Does 1166L
BNSF Need Plans?
~~Hal Industrial~~ Barnett Industrial
BNSF Conflict Sta 16620+00 WL

~~SECRET~~
BNSF Conflict No. 27 & 28

BNSF Conflict No. 57

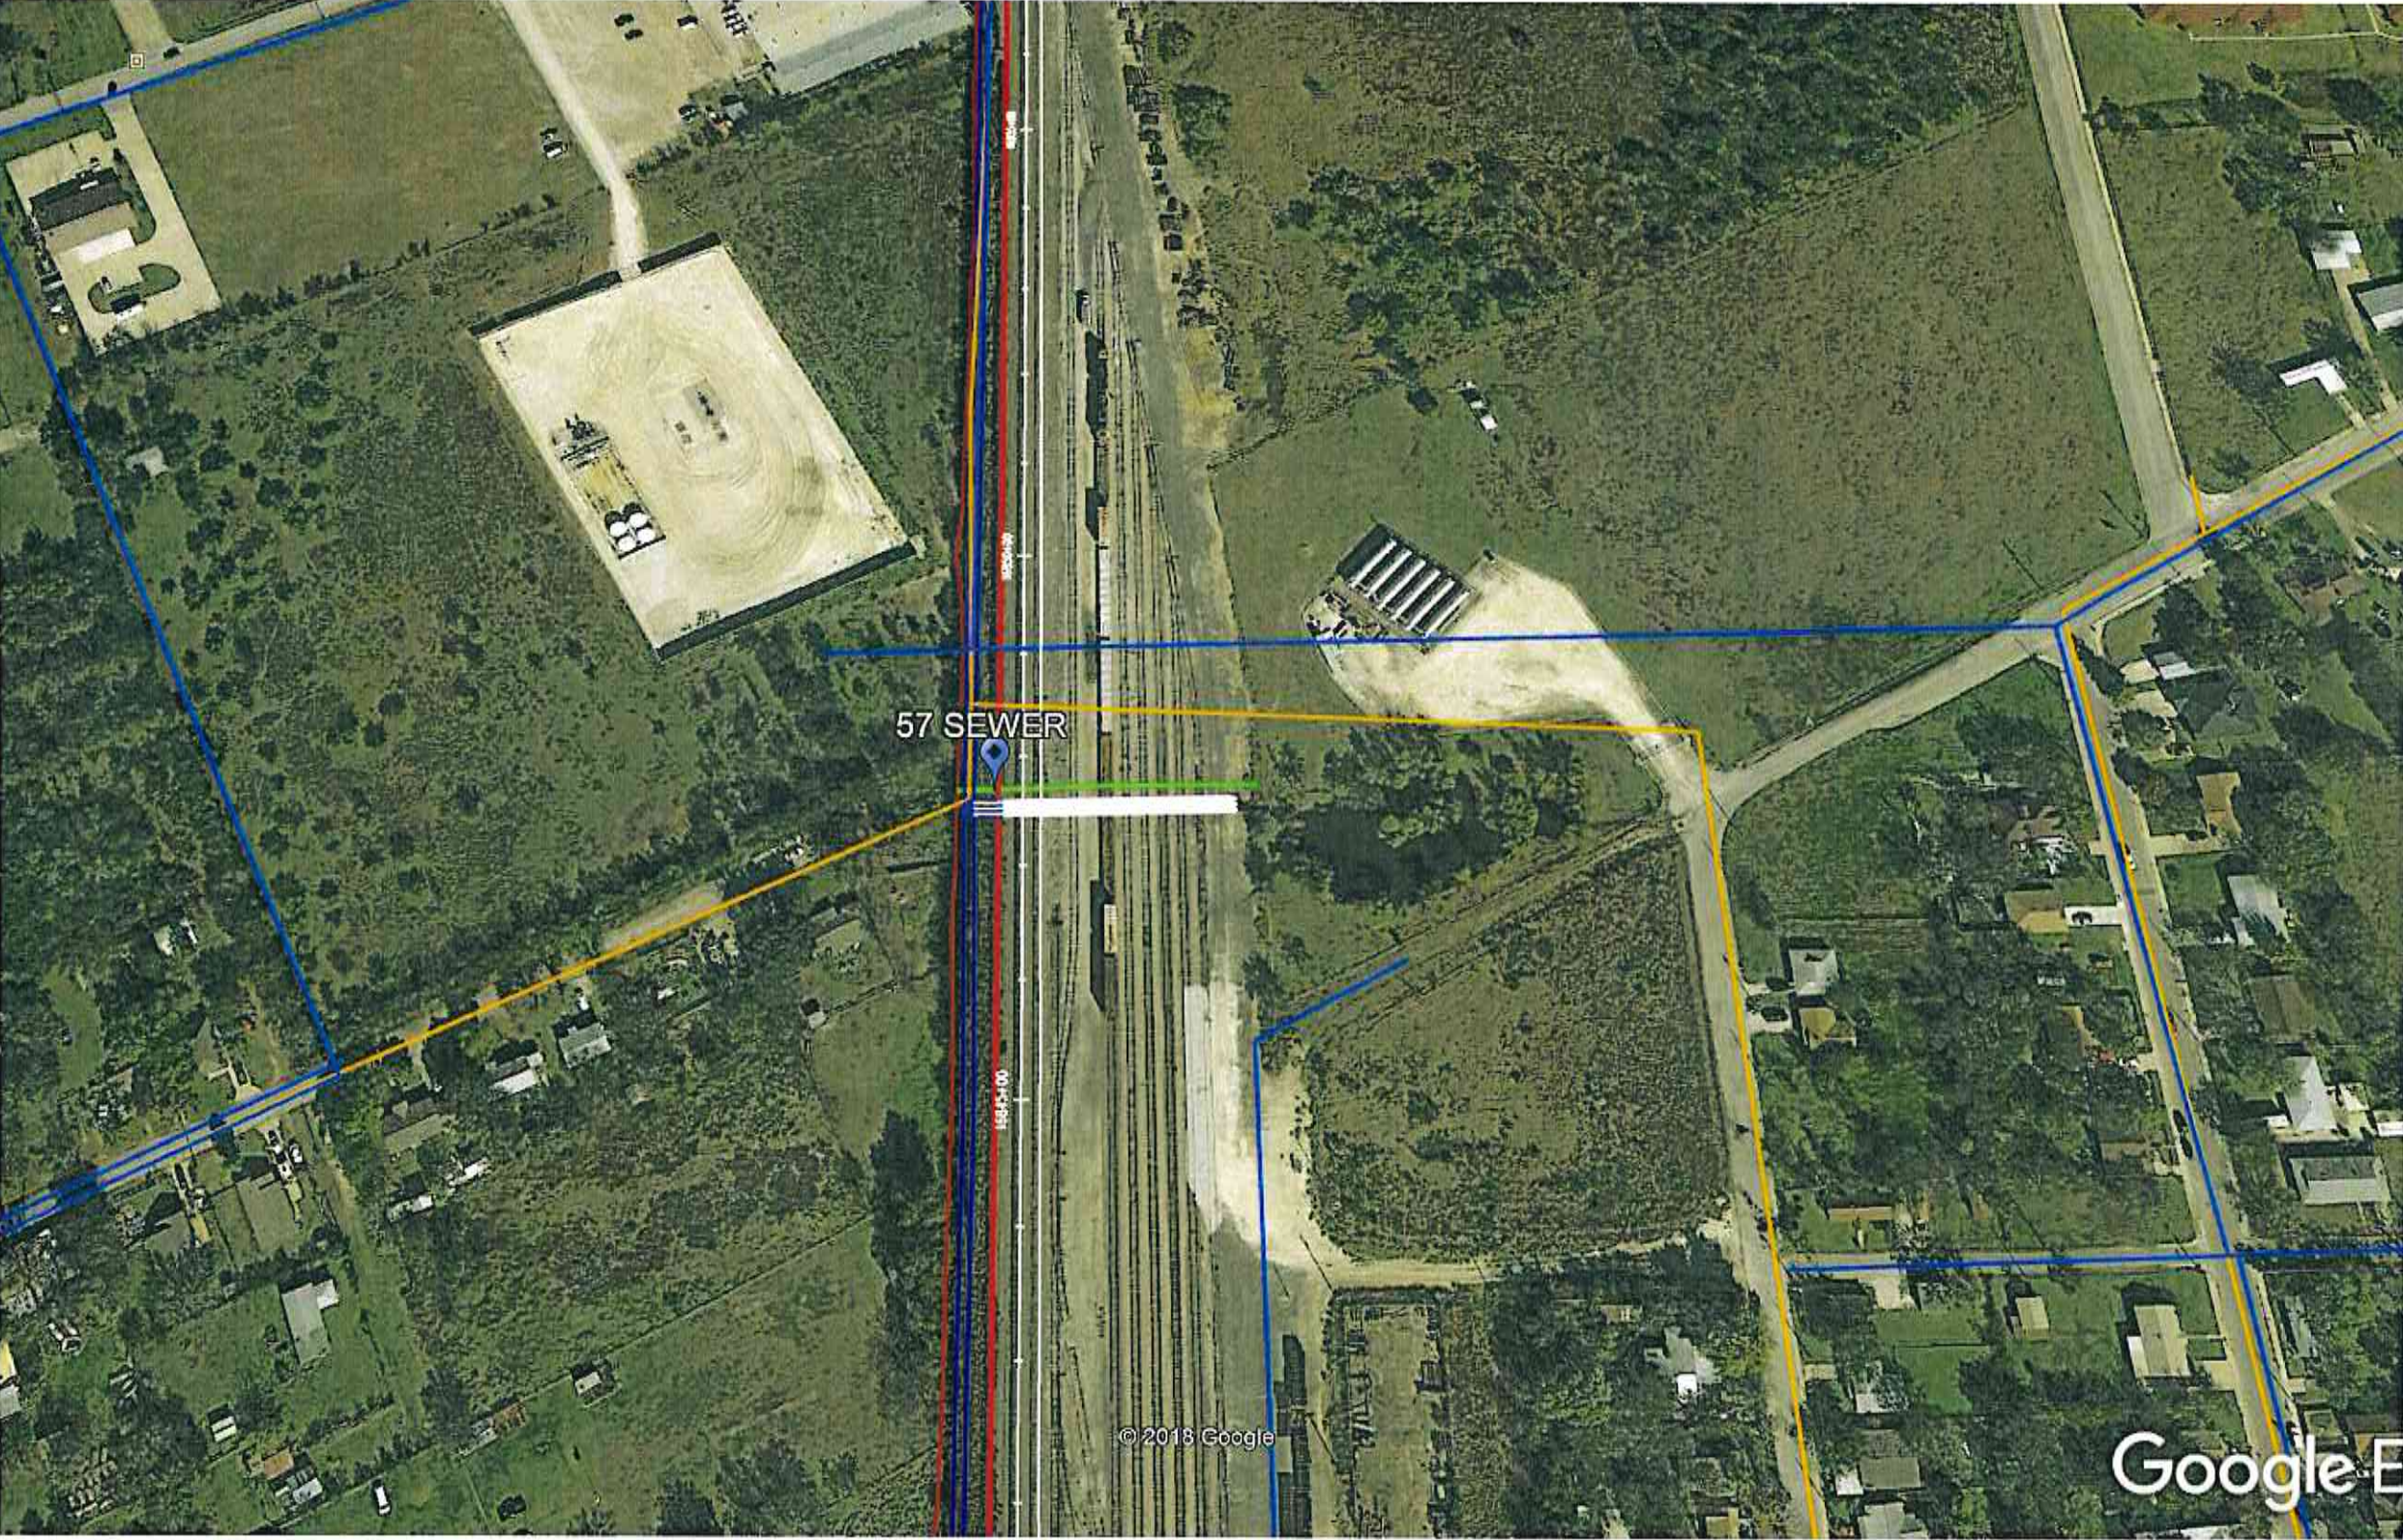
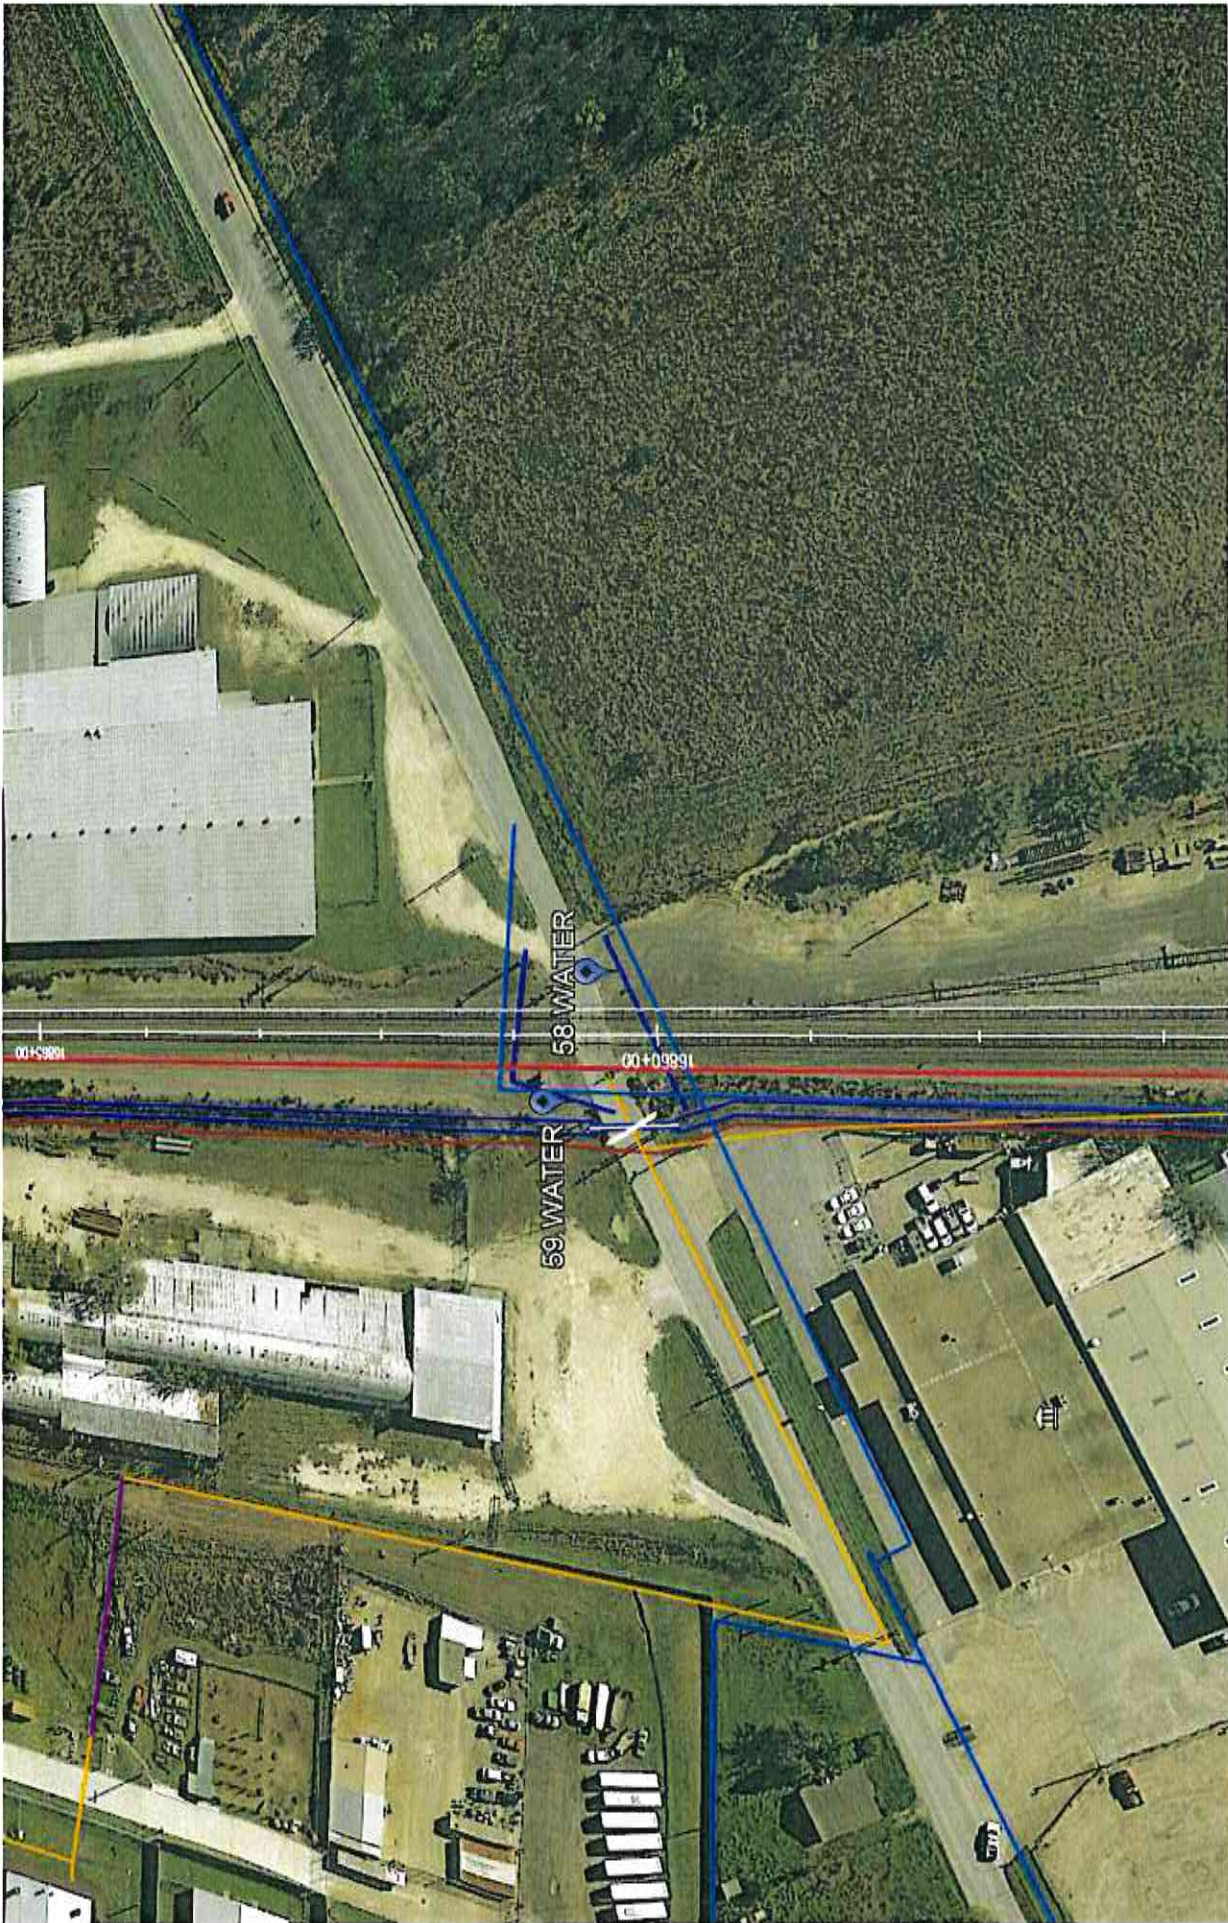
water line existing

MH = 6' deep to top of pipe

sewer alignment correct

dead end
line - no
plans

BNSF Conflict No. 58 & 59

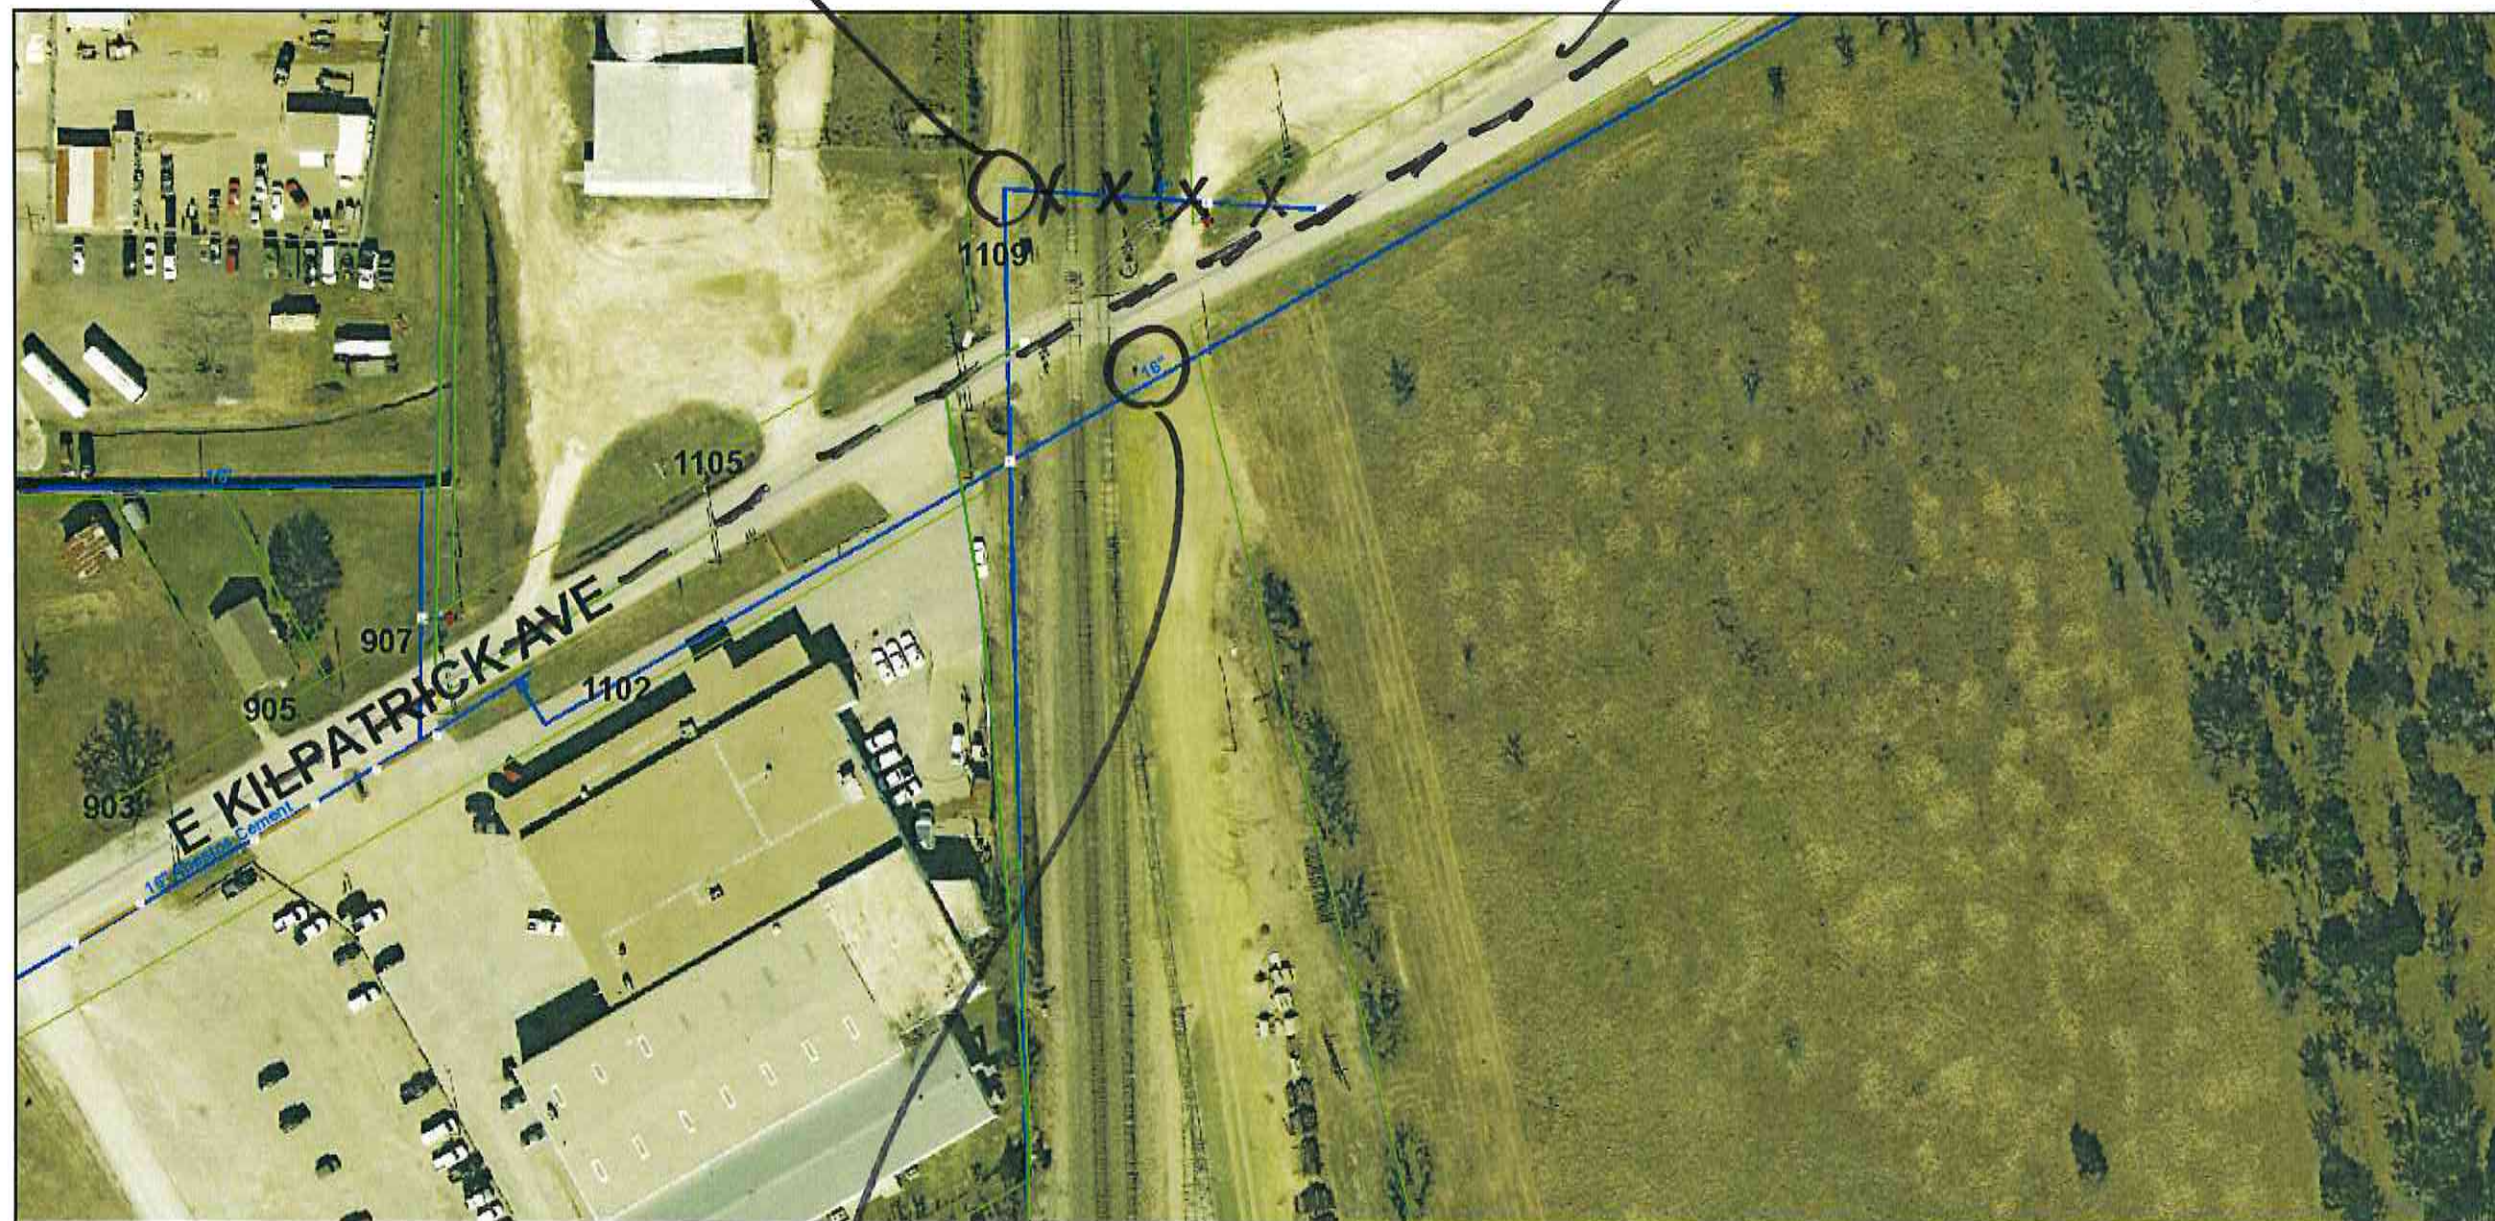
existing 6" WL
centerline
of Kilpatrick

alignment is correct
- U-58 plans
